| DG Flugzeugbau GmbH<br>76646 Bruchsal | I | <b>Technical Note</b><br>No.843/27   | page 1 from 1  |
| Subject                               | : | Spindle drive / screwed joint with adapter   |  |
| Effectivity                           | : | DG-500MB all Ser. No's   |  |

## Hinweis zu TM843/27 Maßnahme 4 Note for TN843/27 instruction 4

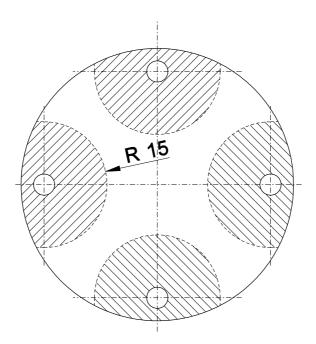
Um ein Verkleben der Schrauben zu verhindern, sollte der schraffiert gezeichnete Bereich nicht mit Klebstoff eingestrichen werden, am Besten vorher abkleben.

To prevent the glue from fixing the bolts, glue should not be applied to the hatched areas. Best to tape the areas before applying the glue.
